Model: BR-P1	Date: 27-May-15	No.: RM263005a
--------------	-----------------	----------------

Subject: Firmware Release Note: PDF		Prepared by: J. Ohno	
From: 1st PP Tech Service Sect., PP Tech Service Dept.			
Classification:	<input type="checkbox"/> Troubleshooting <input type="checkbox"/> Mechanical <input type="checkbox"/> Paper path <input type="checkbox"/> Product Safety	<input type="checkbox"/> Part information <input type="checkbox"/> Electrical <input type="checkbox"/> Transmit/receive <input checked="" type="checkbox"/> Other (Firmware)	<input type="checkbox"/> Action required <input type="checkbox"/> Service manual revision <input type="checkbox"/> Retrofit information <input checked="" type="checkbox"/> Tier 2

Model: Baron-C1/P1		Date: 4-Sep-18	No.: RD179140
Subject: Parts catalog revision – TD sensor		Prepared by: J. Ohno	
From: Sales Strategy Sect., 1st CP Business Dept.			
Classification:	<input type="checkbox"/> Troubleshooting <input type="checkbox"/> Mechanical <input type="checkbox"/> Paper path <input type="checkbox"/> Product Safety	<input checked="" type="checkbox"/> Part information <input type="checkbox"/> Electrical <input type="checkbox"/> Transmit/recei

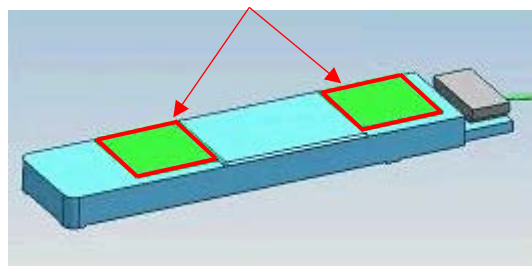
The TD sensor was registered as a service part to meet requests received from the field.

Old P/N	New P/N	Description	Q'ty	Int	Note
-	D2703079	SERVICE PARTS:DENSITY SENSOR:DEVELOPMENT	1	-	Add

Note: Two double-sided seals are included as accessories.

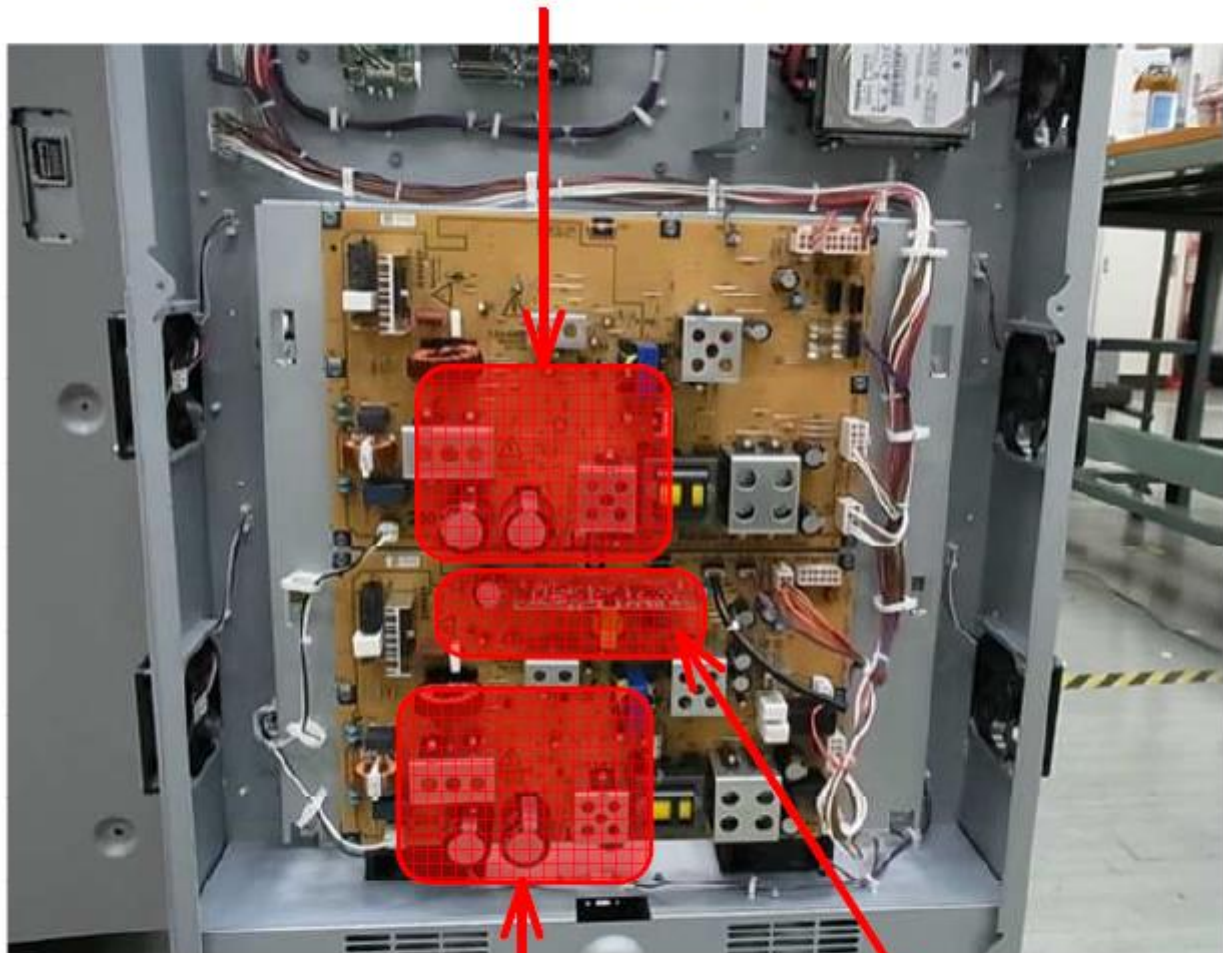
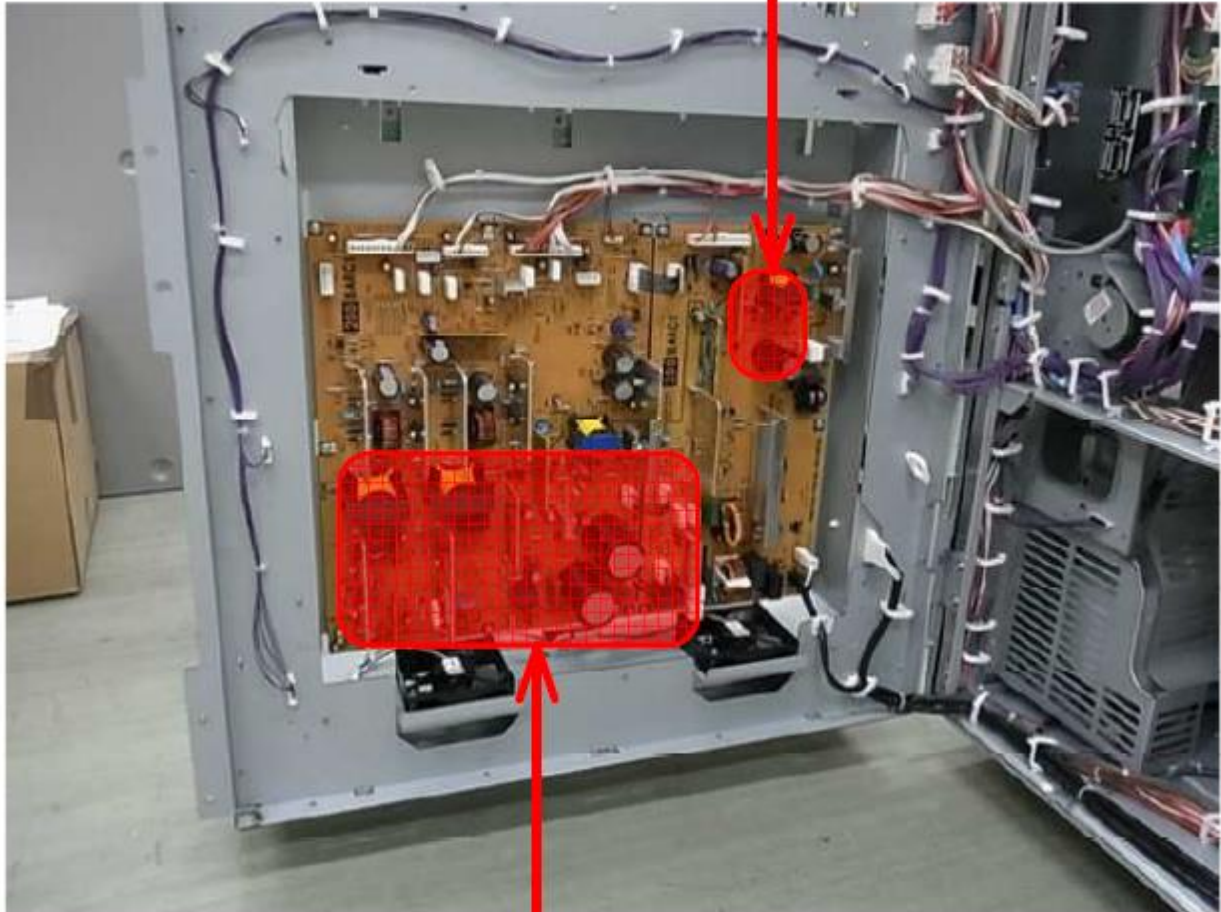
NEVER touch the areas outlined in red in the photos below, to prevent electric shock caused by residual charge.

Residual charge of about 100V-400V remains in the AC circuits on the PSU board for several months even when the board has been removed from the machine after turning off the machine power and unplugging the power cord.

The procedure to discharge residual charge from the machine by unplugging the power cord from the AC wall outlet and pressing the main power switch works only for the DC circuits on this board. Residual charge remains in the AC circuits.

Please add the following caution in the field service manual in this section:
 Replacement and Adjustment > Common Procedures > Controller Box Removal

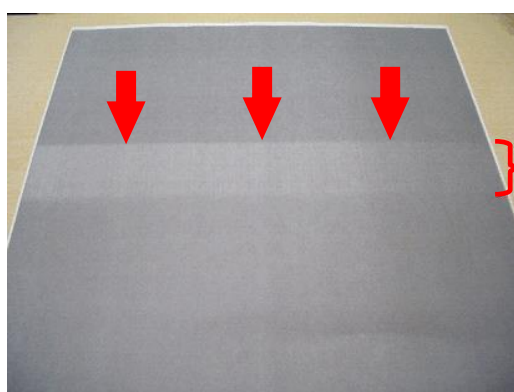
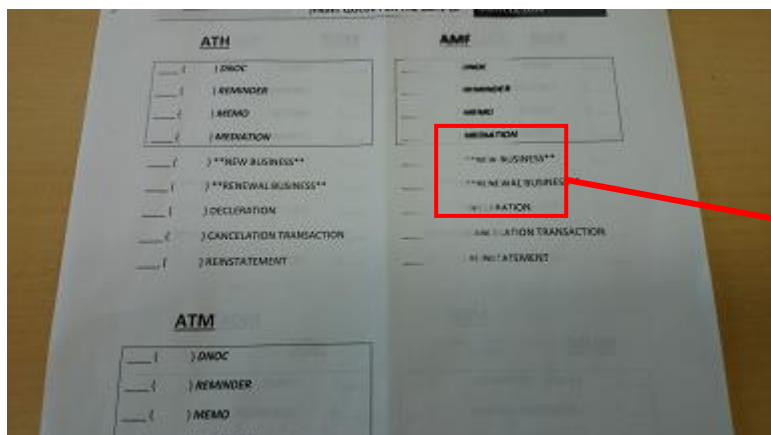
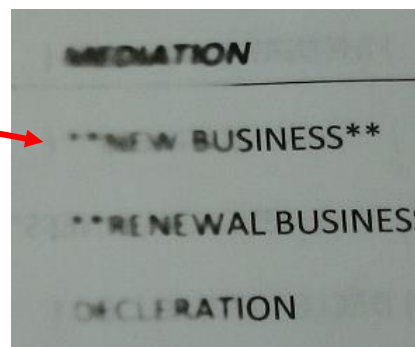
Halftone and text images appear low in density or blurred. The symptom is observed across the width of the drum charge unit at intervals corresponding to the drum circumference.

In addition to the above symptom, SC401 and dirty background may also occur, if the potential control pattern is created in the affected area during toner supply control (Process Control).

NOx (nitrogen oxides) generated in the drum charging process combine with the lubricant powder (zinc stearate) and this absorbs moisture, which adheres to the drum surface, if the machine is left unused for an extended period, causing poor drum charge in the affected area.

Do the following SP modification and part replacements.

2. Update the Engine firmware to Ver.1.03:00 or later.

As a solution to the Blurred Image problem, the threshold that triggers the automatic operation of "Clear blurred image" in Strong mode was revised.

New Mylar sheet to improve airflow in the charge unit

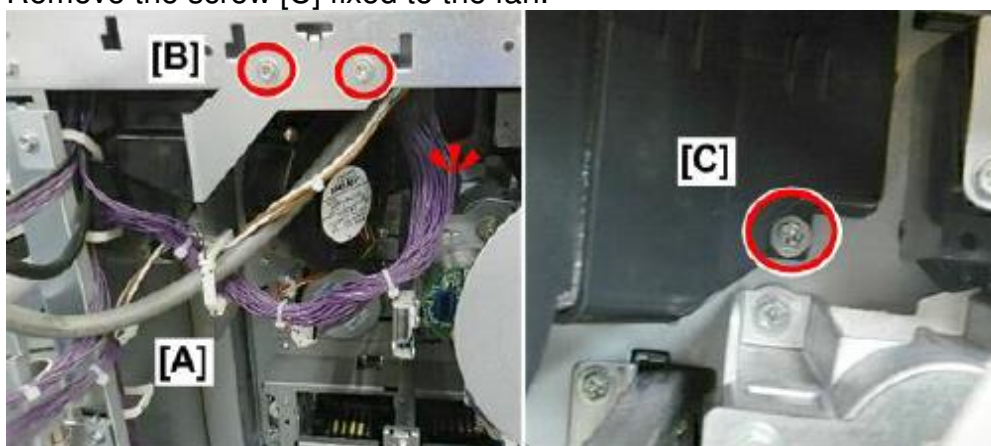
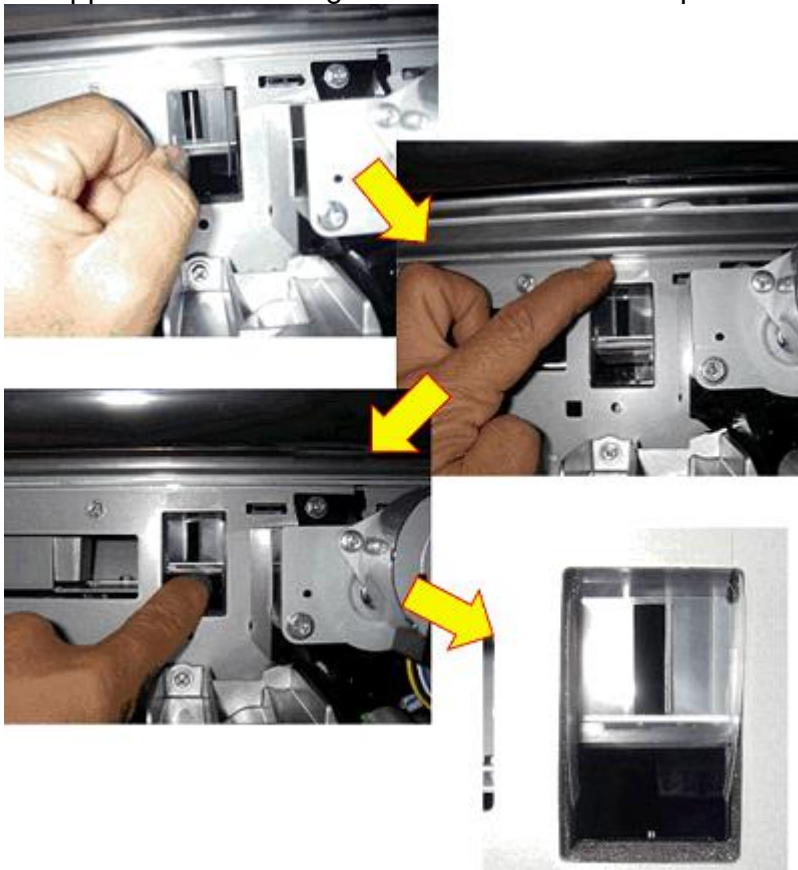
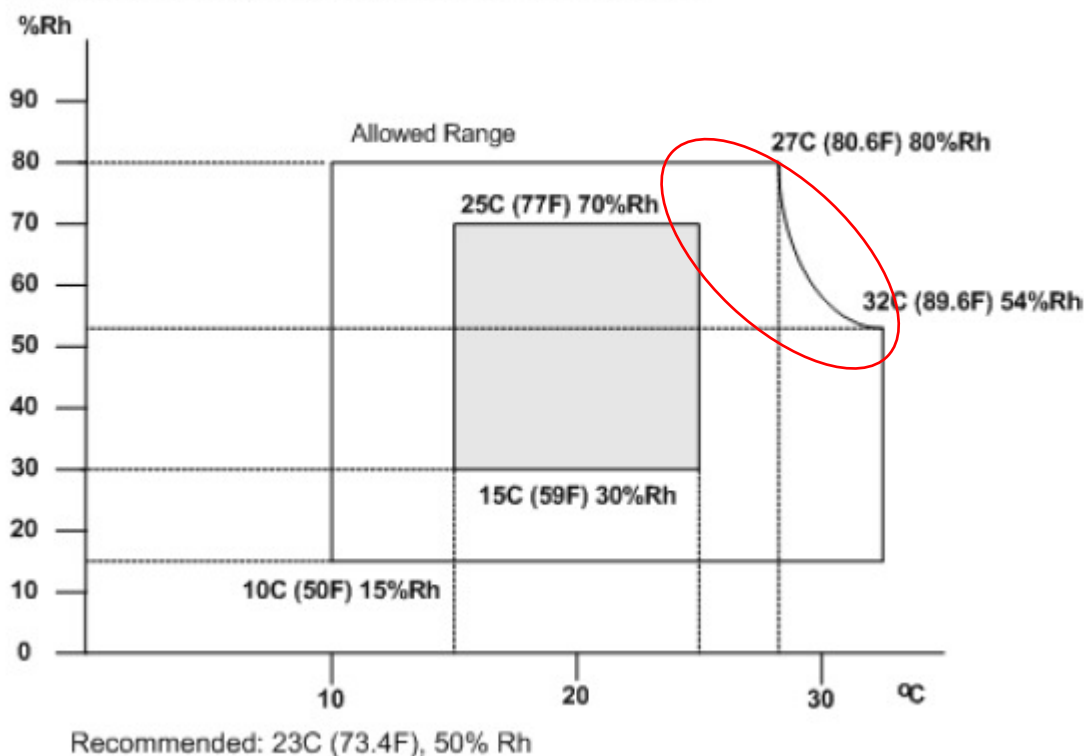
Adding this Mylar sheet to the entrance of the charge unit intake fan strengthens the performance of the fan in removing NOx.

1. Open the controller box.
2. At the bottom right (viewed from the rear), release the purple harnesses [A].
3. Remove the bracket [B].
4. Remove the screw [C] fixed to the fan.

5. Remove the bracket together with the Ozone Air Intake fan.

6. Attach the Mylar sheet (double-sided tape) to the opening of the charge unit that appears after having removed the fan in the previous step.

Old p/n	New p/n	Description	Q'ty	Int	Note
-	D1791573	OZONE FILTER:EXHAUST:PAPER EXIT SUB-UNIT	1	-	Add

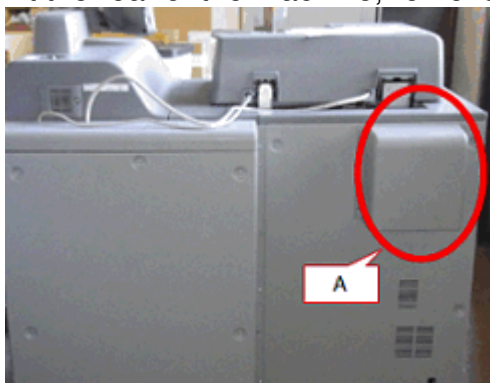
Make the following SP settings, which will increase the airflow around the charge unit and further remove ozone.

1. At the rear of the machine, remove the vent cover [A].

2. Remove the liner from the double-sided tape on the ozone filter and attach the filter to the reverse side of the vent cover.

SC465 (PTR motor error)

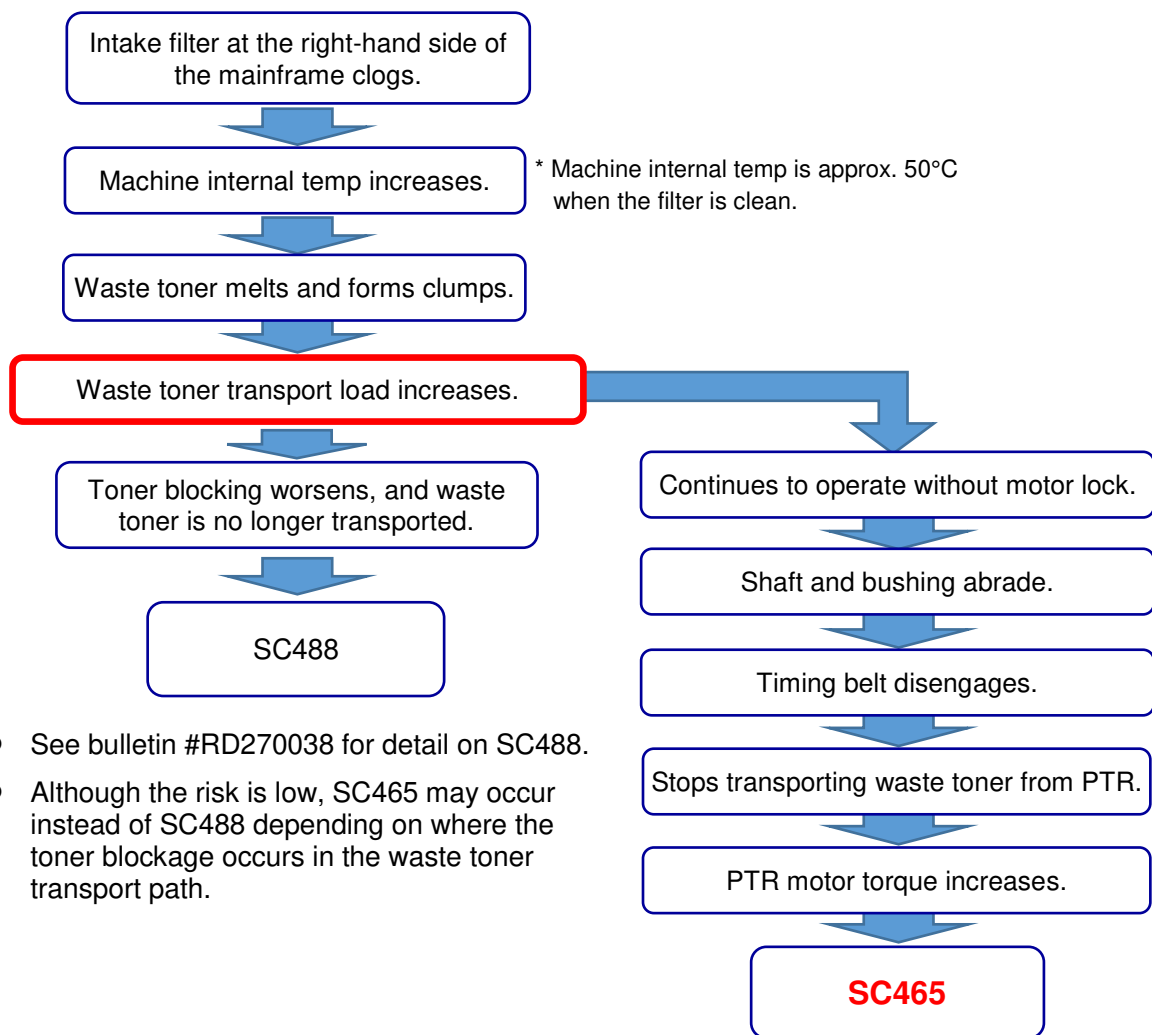
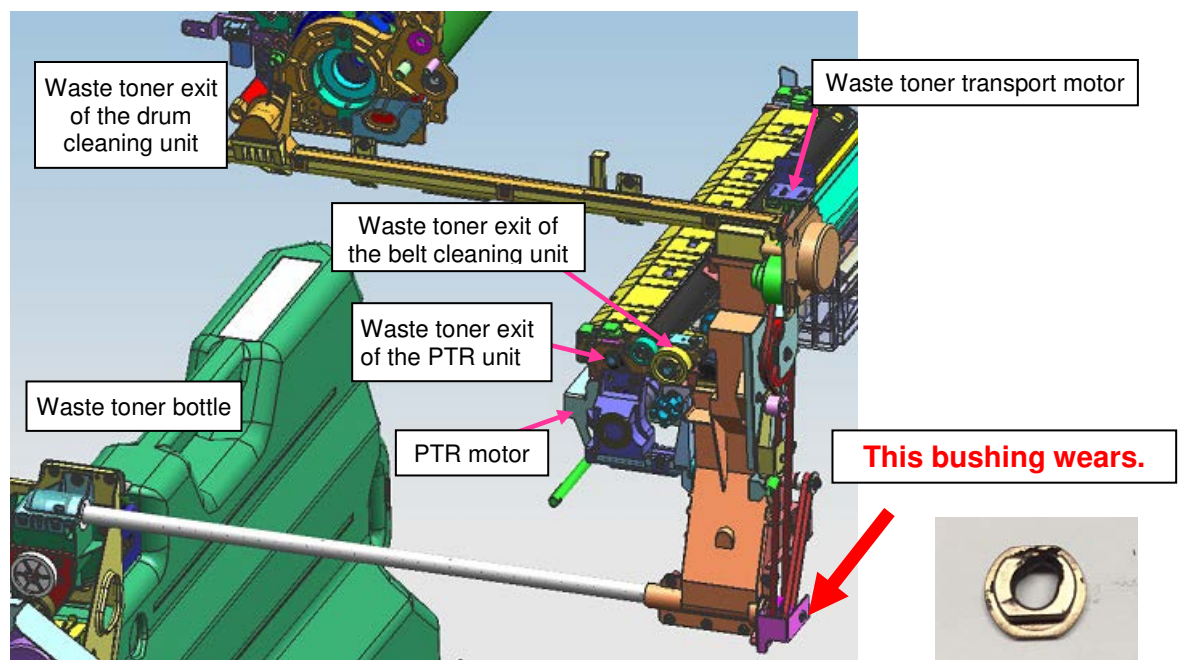
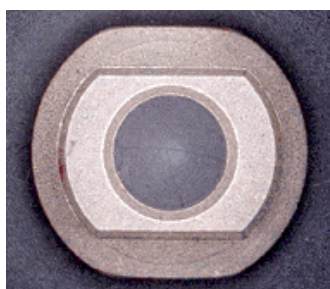
- See bulletin #RD270038 for detail on SC488.
- Although the risk is low, SC465 may occur instead of SC488 depending on where the toner blockage occurs in the waste toner transport path.

The following conditions increase the risk of the symptom:

- High room temperature
- The machine is installed close to the wall with hardly any or no space at all.
- The machine generates high print volume.
- Intake filter at the right-hand side of the mainframe is clogged.
- The machine experienced SC488 in the past. The waste toner transport unit and bushing were not replaced at that time.

- Check the above bushing (p/n: B1202063). If it is abraded and requires replacement, replace it together with the waste toner unit (p/n: D1796528).
